AGENDA

**PLANNING & ZONING COMMISSION REGULAR MEETING
FRIDAY, SEPTEMBER 20, 2024 - 10:00 AM
MCALLEN DEVELOPMENT CENTER, 311 N. 15TH STREET
EXECUTIVE CONFERENCE ROOM 3**

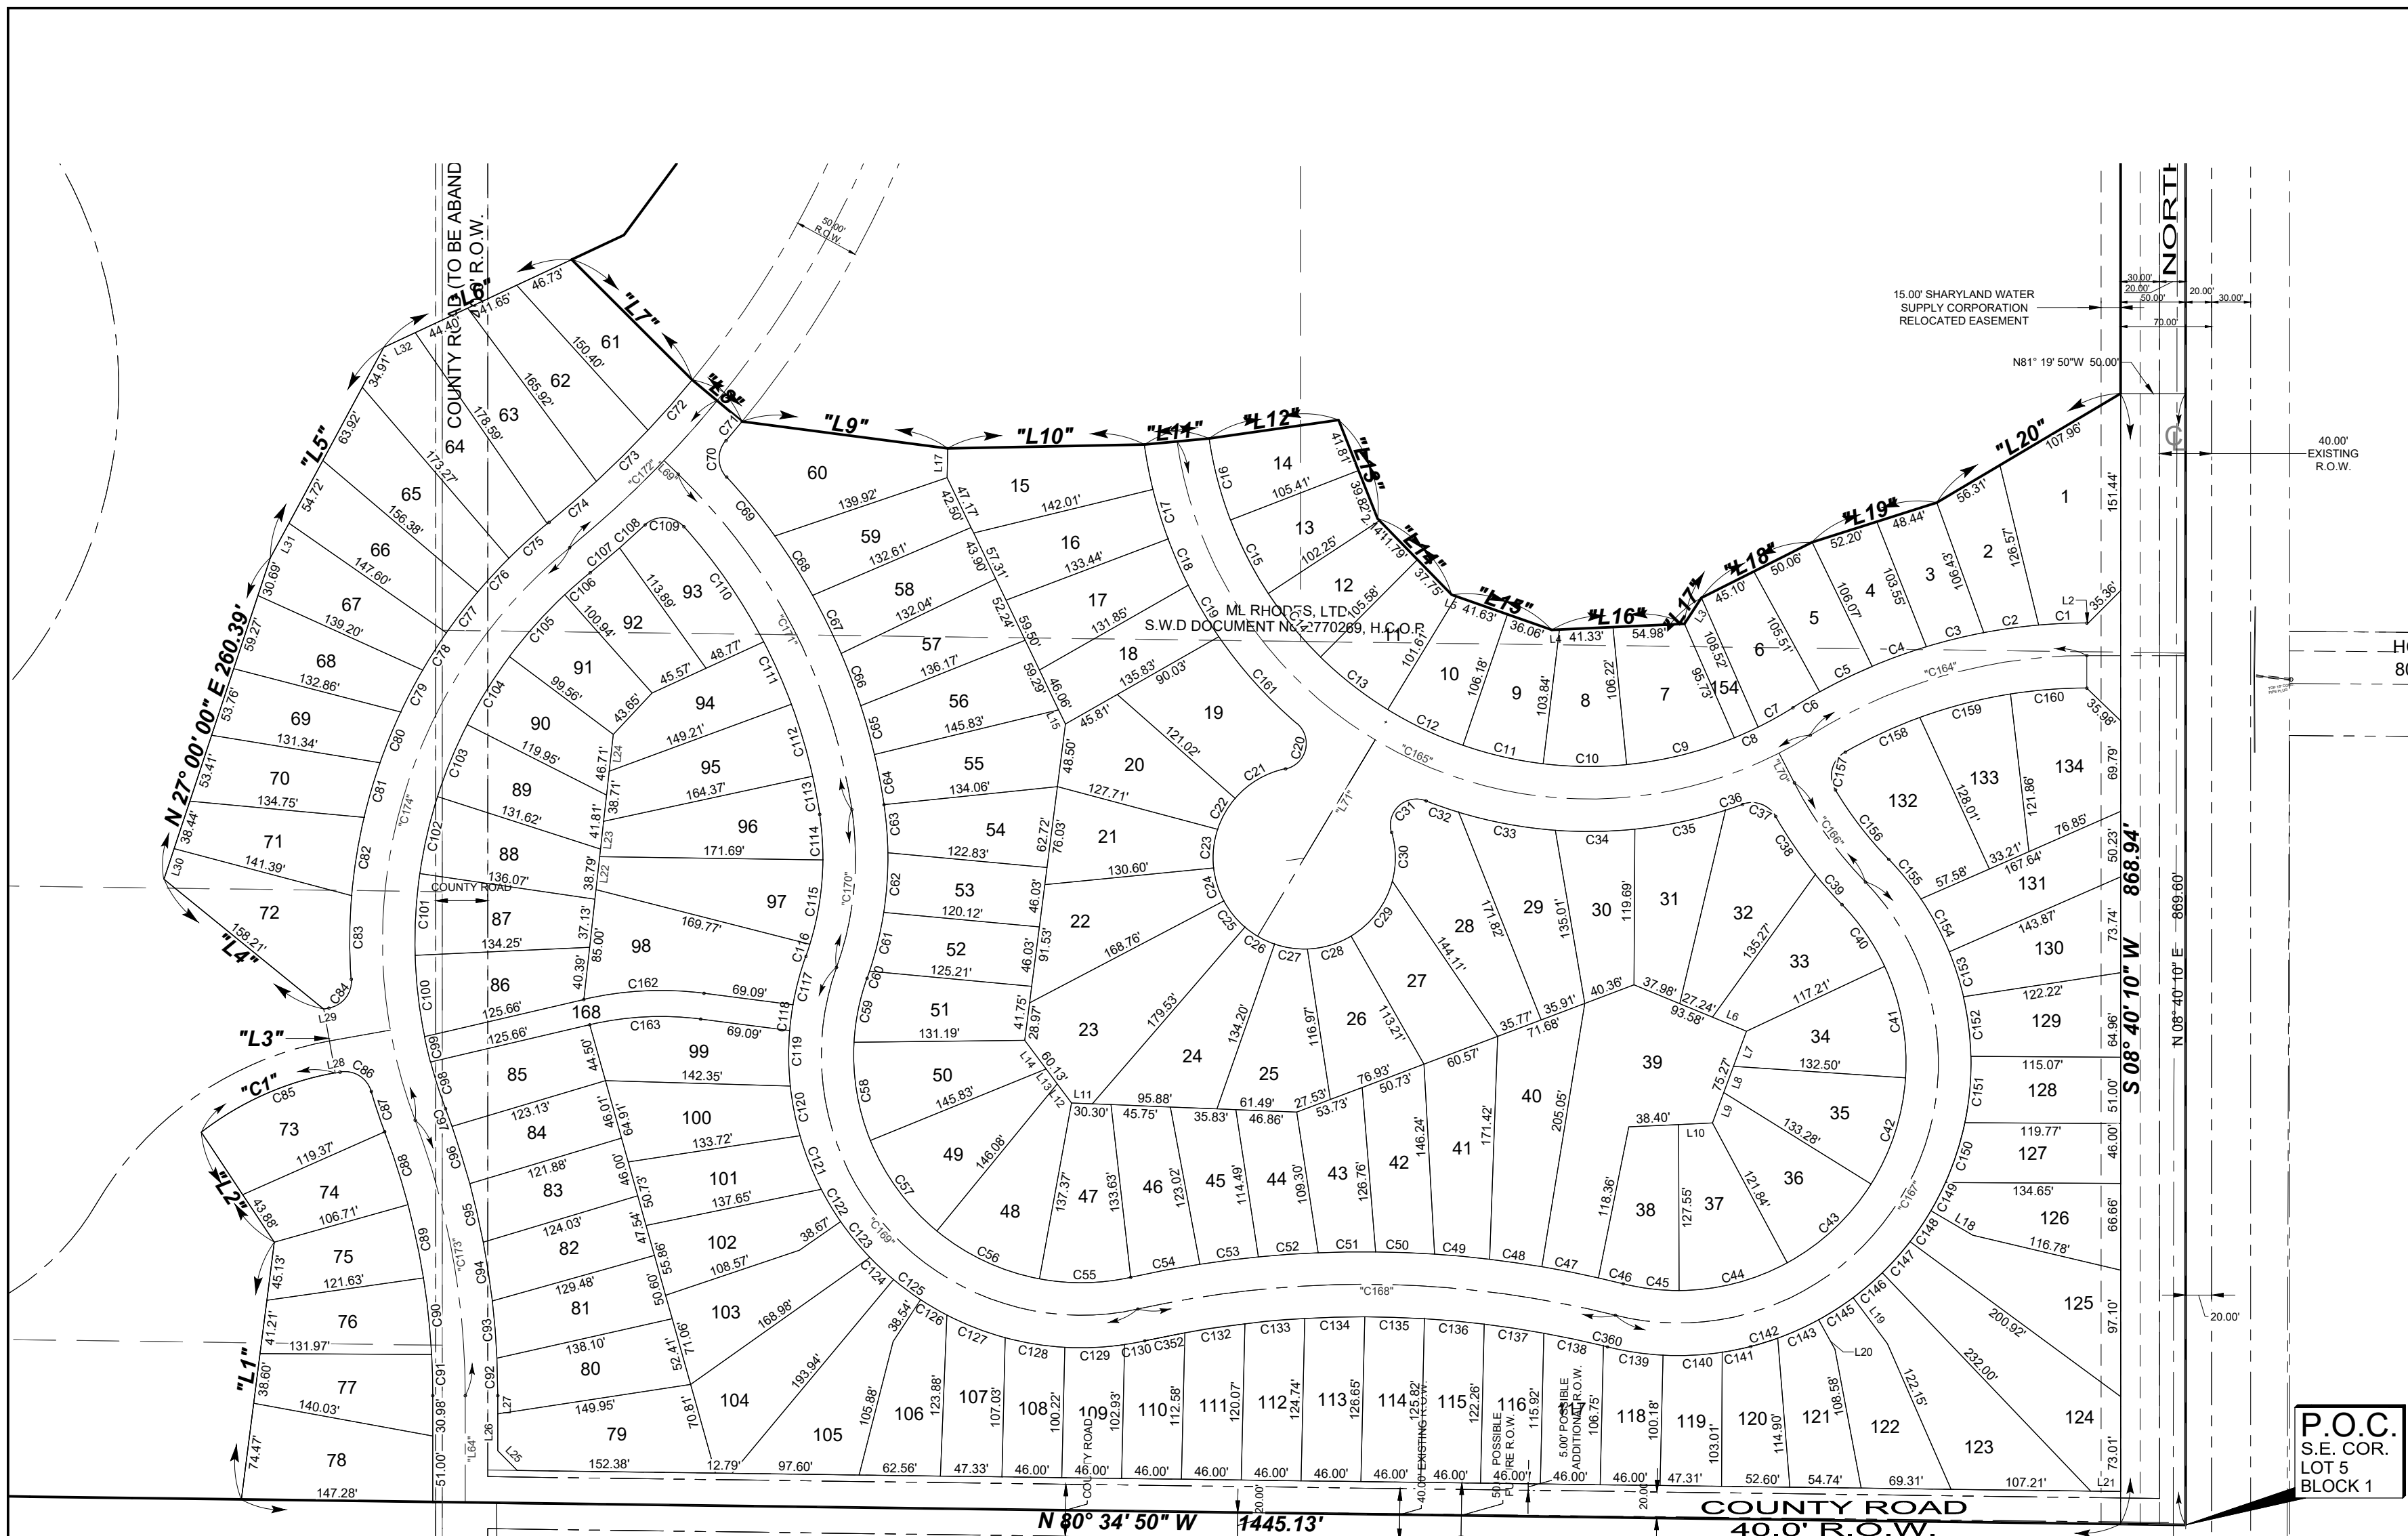
SUBDIVISION NAME: LAS BRISAS PHASE II	
REQUIREMENTS	
STREETS AND RIGHT-OF-WAYS	
<p>North 29th Street (N. Rooth Road): Dedication as needed for 50 ft. from centerline for 100 ft. total ROW. Paving: 65 ft. Curb & gutter: on both sides - Correct the street label to "North 29th Street (Rooth Road)" and show on plat - Please label Center Line. - Dedication must be finalized once centerline is established. - Please show and label R.O.W. from centerline after the dedication. - Show document number for existing ROW dedication and submit documents for staff review. - Sharyland easement may not overlap the street ROW. Any abandonment must be done by separate document and referenced on plat. - Clarify if existing 30 ft. ROW is a portion of the HCID No. 1 Canal ROW, prior to final. - North 29th Street dedication to be in line with ROW dedication for Las Brisas Phase I. **Subdivision Ordinance: Section 134-105 **Monies must be escrowed if improvements are required prior to final **COM Thoroughfare Plan</p>	Non-compliance

<p>County Road E/W: for 30 ft. dedication of ROW from centerline for 60 ft. total ROW Paving: 40 ft. Curb & gutter: both sides - Label the centerline. - Dedication must be finalized once centerline is established. - All comments referencing "possible and future" must be removed as it should be labeled as total ROW or ROW dedicated by this plat. - Sharyland easement may not overlap the street ROW. Any abandonment must be done by separate document and referenced on the plat. - Show and label ROW from centerline after dedication. - Provide document number for ROW dedication and provide a copy for staff review, prior to final. **Subdivision Ordinance: Section 134-105 **Monies must be escrowed if improvements are required prior to final **COM Thoroughfare Plan</p>	Non-compliance
<p>Interior Streets: 50 ft. ROW Paving: 32 ft. Curb & gutter: both sides - Street names will be finalized prior to recording. - Show the R.O.W. for all streets. - Please finalize all ROW requirements prior to final. - Temporary paved turnarounds are required at the end of streets not continuing at this time by plat or separate document prior to final. **Subdivision Ordinance: Section 134-105 **Monies must be escrowed if improvements are required prior to final **COM Thoroughfare Plan</p>	Non-compliance

<p>* 1,200 ft. Block Length Revisions needed: - Dimensions of centerline is needed prior to final. **Subdivision Ordinance: Section 134-118</p> <p>* 900 ft. Block Length for R-3 Zone Districts **Subdivision Ordinance: Section 134-118</p> <p>* 600 ft. Maximum Cul-de-Sac: Cul-de-sac street length does not apply provided that the development uses the "coving method" and emergency access walks/drives are provided, per agreement. Revisions needed: - Please provide dimensions of Cul-de-Sacs. - Please clarify if islands are proposed and provide paving dimensions around all islands to determine compliance prior to final. ***Paving must be 96 ft. in diameter face to face and island must meet 32 ft. paving all around and must be fire lane striped, as applicable. **Subdivision Ordinance: Section 134-105</p>	<p>Non-compliance</p>
	<p>NA</p>
	<p>Non-compliance</p>
<p>ALLEYS</p>	
<p>ROW: 20 ft. Paving: 16 ft. *Alley/service drive easement required for commercial/multi-family properties **Subdivision Ordinance: Section 134-106</p>	<p>NA</p>

<p>SETBACKS</p>	
<p>* Front: 20 feet minimum or greater for easements, or as shown on "Front Setback Table" greater applies, as per agreement. - No Front Setback Table is shown on plat, please clarify and revise as needed. **Zoning Ordinance: Section 138-356</p>	<p>Non-compliance</p>
<p>* Rear: 10 ft. or greater for easements - Clarify rear setback as there are indications of a possible 11 ft. easement at the rear of the lots. **Zoning Ordinance: Section 138-356</p>	<p>Non-compliance</p>
<p>* Sides: 5 feet or greater for easement, as per agreement - Proposed subdivision complies with minimum setback requirements, as per the agreement. **Zoning Ordinance: Section 138-356</p>	<p>Applied</p>
<p>* Corner: 10 feet or greater for easements **Zoning Ordinance: Section 138-356</p>	<p>Applied</p>
<p>* Garage: 18 feet except where greater setback is required; greater setback applies. **Zoning Ordinance: Section 138-356</p>	<p>Applied</p>

BUFFERS	
<ul style="list-style-type: none"> * 6 ft. opaque buffer required from adjacent/between multi-family residential and commercial, and industrial zones/uses and along North 29th Street (Rooth Road) and County Road. - Revise plat note as applicable, wording to be finalized prior to final. **Landscaping Ordinance: Section 110-46 	Non-compliance
<ul style="list-style-type: none"> * 8 ft. masonry wall required between single family residential and commercial, industrial, or multi-family residential zones/uses - Revise plat note as shown above, prior to final. **Landscaping Ordinance: Section 110-46 	Non-compliance
<ul style="list-style-type: none"> *Perimeter buffers must be built at time of Subdivision Improvements. 	Required
NOTES	
<ul style="list-style-type: none"> * No curb cut, access, or lot frontage permitted along North 29th Street (Rooth Road) and County Road. - Revise plat note as applicable, wording to be finalized prior to final. **Must comply with City Access Management Policy 	Non-compliance

<p>* Traffic Impact Analysis (TIA) required prior to final plat. - As per Traffic, Master TIA approved with conditions.</p>	<p>Applied</p>
<p>COMMENTS</p>	
<p>Comments: - Please use a wider/bold line for the subdivision boundary on all sides. - Need to include document numbers for easements, R.O.W.'s etc. shown on plat. - No easements are shown on plat, clarify and revise as applicable. - Any abandonment must be done by separate document, prior to final and referenced on plat. - Clarify use of lots 168 and 154 and revise lots to be in line with numbering scheme of the plat - Clarify if N/S County Road has been abandoned, if so provide a document number on the plat. * Must comply with City's Access Management Policy. * Must comply with the Agreement and Public Improvement District (PID) conditions. * Must comply with other requirements, as may be applicable, prior to final</p>	<p>Applied</p>
